# Access Compliance Report

## Public Rights-of-Way

Intersection ID: 31794	Main Street: ROMARE_BEARDEN_DR	Cross Street: SPRING_FOREST_DR	Location: NE
ADA ID: 9C210862ECC1	Ramp Type: Perp	Initial Pass/Fail: Fail	Overall Compliance: No
Severity Score: 22.5			
Codes/Mitigation Info/Possible Solution		Field Measurements/Component Compliance

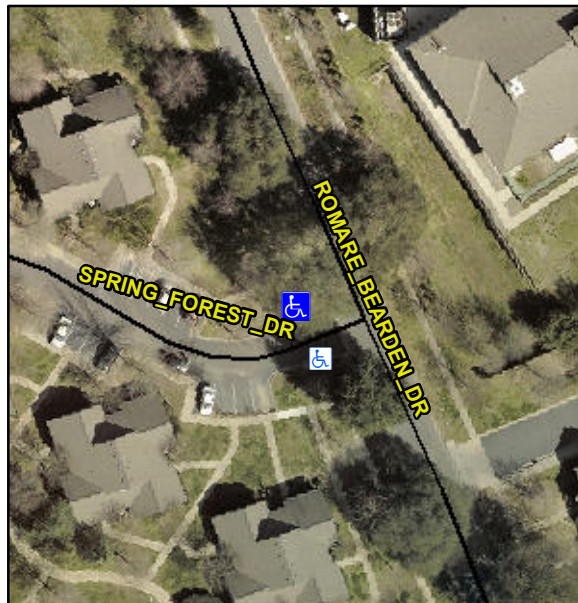
**Not Found, R304.5.1, R304.2.2, R304.5.3**

Compliance	Description	Data	Compliance	Description	Data
N/A	Ramp Length (in)	62.0	No	Ramp Slope (%)	10.1
No	Ramp Width (in)	47.0	No	Ramp XSlope (%)	4.9
N/A	Flare Type LT	N/A	N/A	Flare Type RT	N/A
N/A	Flare Slope LT (%)	N/A	N/A	Flare Slope RT (%)	N/A
N/A	Flare Traversable LT?	N/A	N/A	Flare Traversable RT?	N/A
N/A	Landing Length (in)	N/A	N/A	DWS Provided?	N/A
N/A	Landing Width (in)	N/A	N/A	DWS Contrast?	N/A
N/A	Landing Slope (%)	N/A	N/A	DWS Length (in)	N/A
N/A	Landing X Slope (%)	N/A	N/A	DWS Full Width?	N/A
N/A	Landing Curb? (Y/N)	N/A	N/A	DWS Offset (in)	N/A
N/A	Shared Landing?	N/A			
N/A	Gutter Ponding?	N/A	N/A	Gutter Slope (%)	N/A
N/A	Gutter Lip Ht (in)	N/A	N/A	Gutter X Slope (%)	N/A
N/A	Painted X Walk1?	No	N/A	Painted X Walk2?	N/A
	X Walk 1 Direction	To S		X Walk 2 Direction	N/A
N/A	X Walk 1 Width (in)	N/A	N/A	X Walk 2 Width (in)	N/A
	X Walk 1 Slope (%)	3.1		X Walk 2 Slope (%)	N/A
	X Walk 1 X Slope (%)	3.2		X Walk 2 X Slope (%)	N/A

**Remove & Replace Entire Ramp.**
